PROJECT: DURKIN PARK ELEMENTARY SCHOOL ANNEX

PBC NO.: 05540

ISSUE: ISSUE FOR ADDENDUM NO. 1

ESK-3

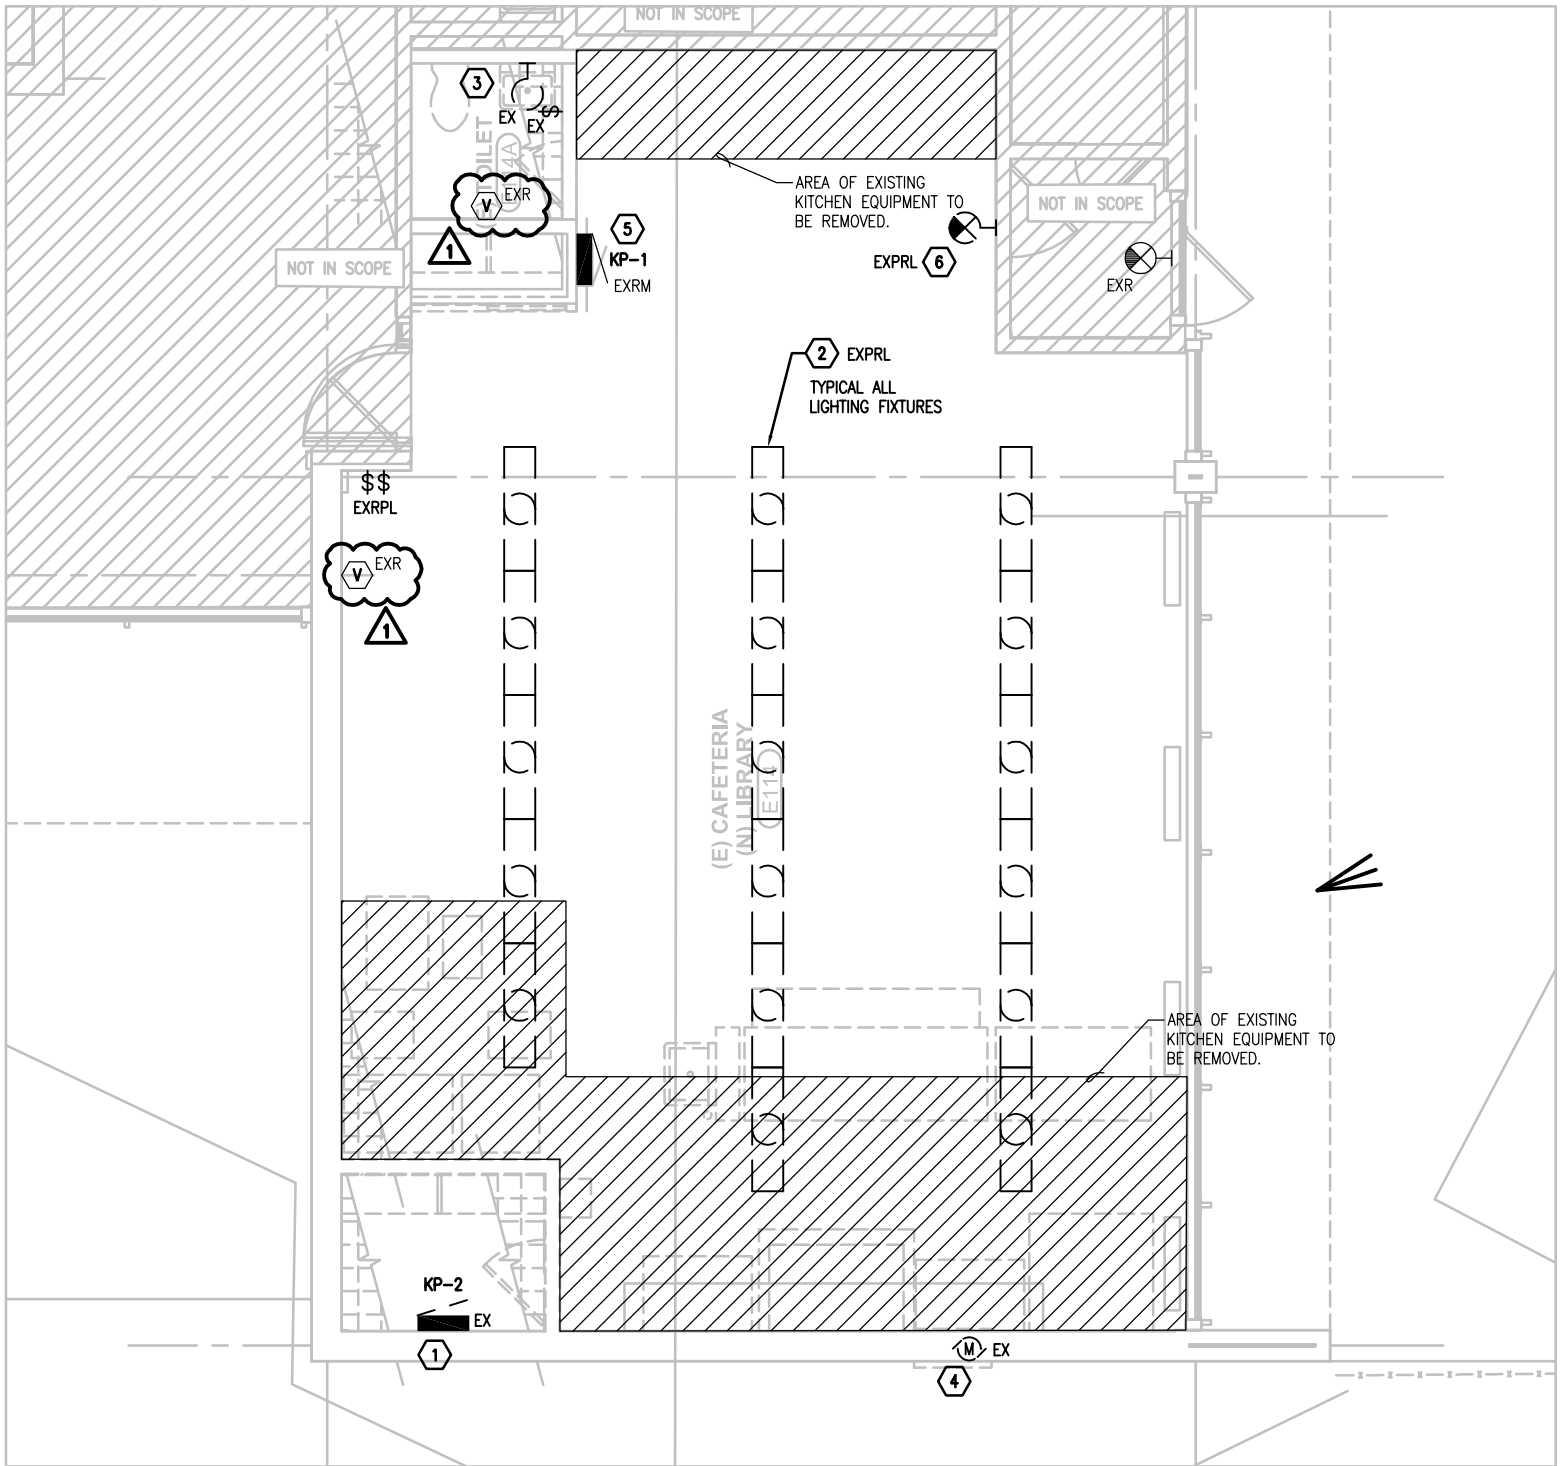
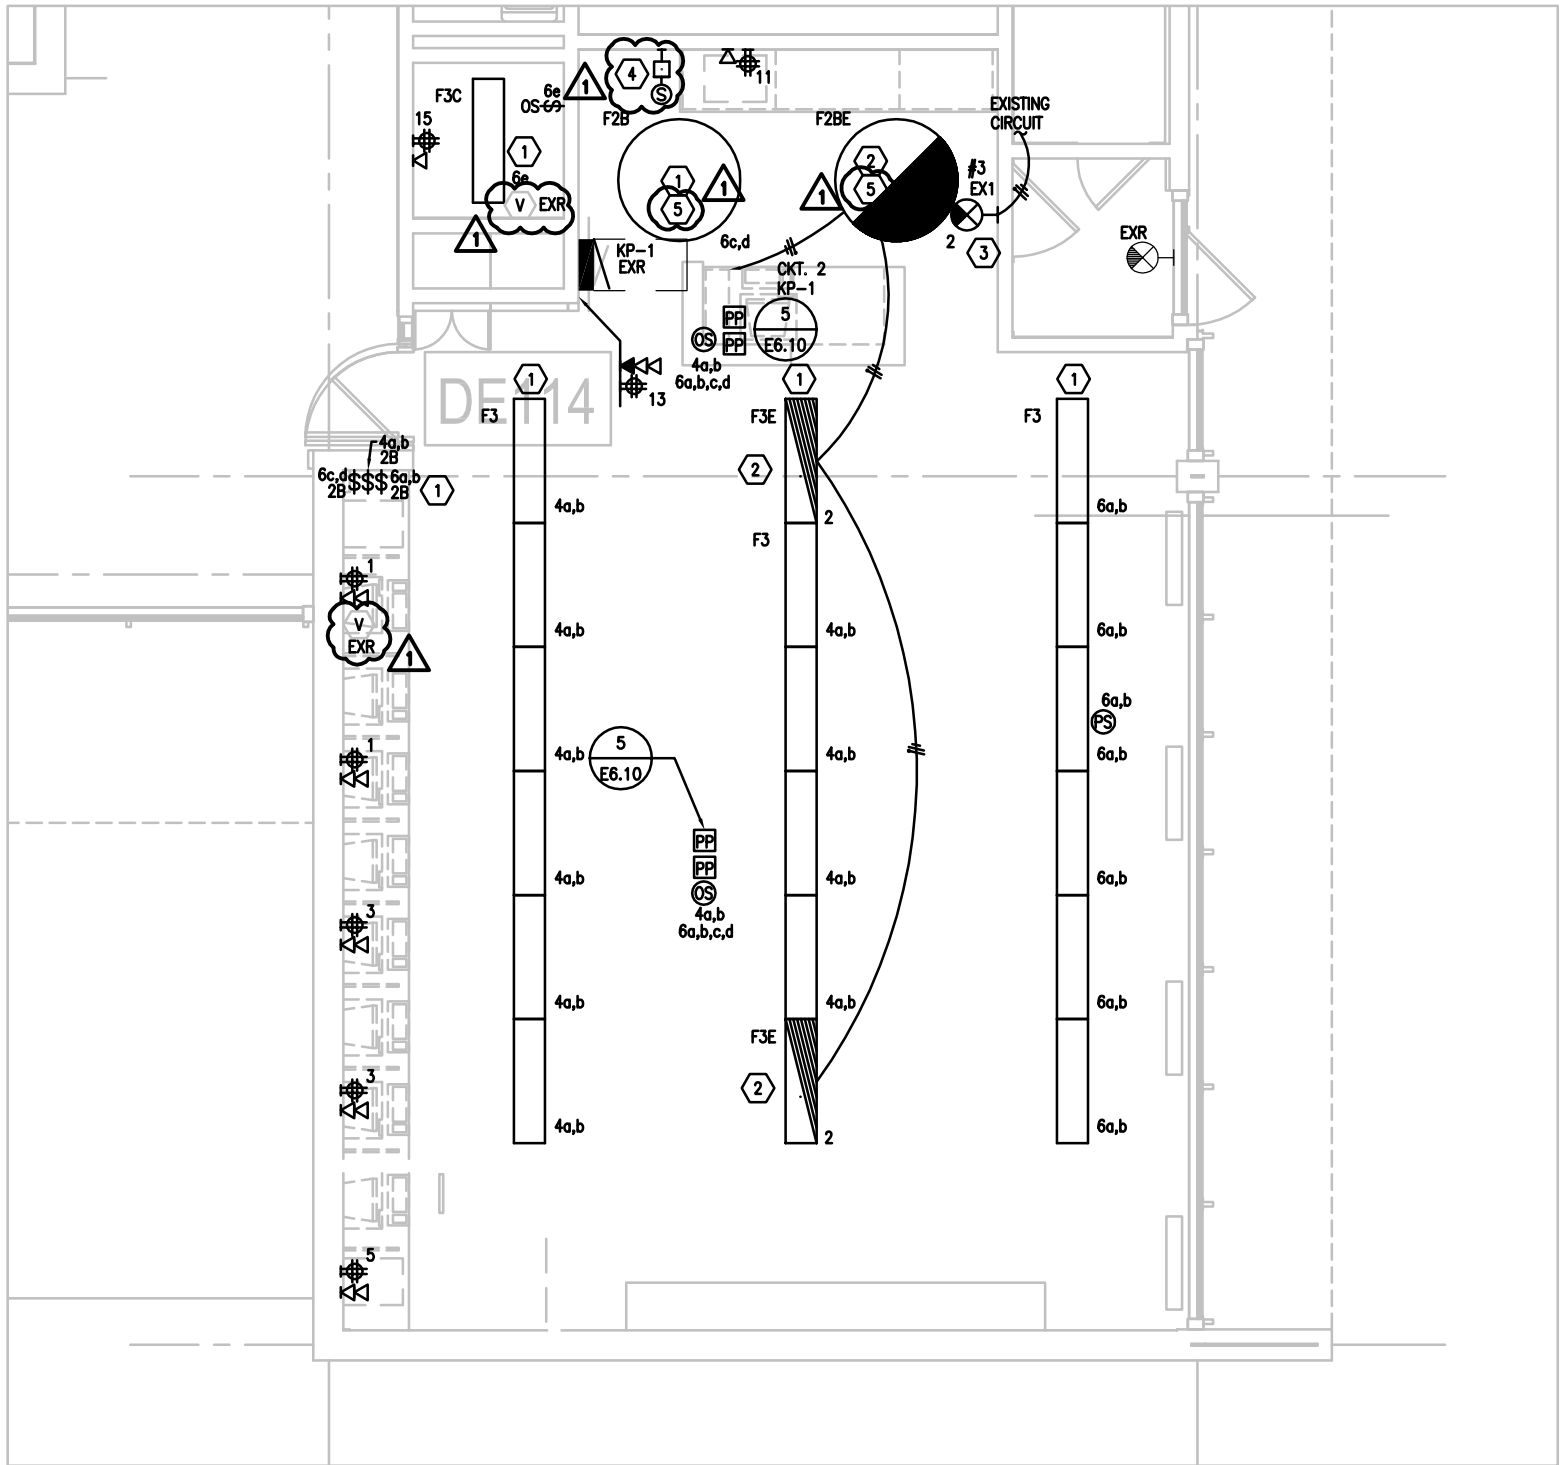
3 RECONNECT NEW EXIT SIGN LEFT FROM PREVIOUSLY DEMOLISHED EXIT SIGN AT SAME LOCATION.

4 PROVIDE NEW CONCEALED CONDUIT WHERE POSSIBLE AND SURFACE MOUNTED RACEWAY WHERE CONCEALED CONDUIT IS NOT POSSIBLE BACK TO ICC IN EXISTING OFFICE.

5 PROVIDE SURFACE MOUNTED VERSION OF FIXTURE SHOWN AND ALL ASSOCIATED MOUNTING PIECES REQUIRED FOR A PROPER SURFACE MOUNTED INSTALLATION.
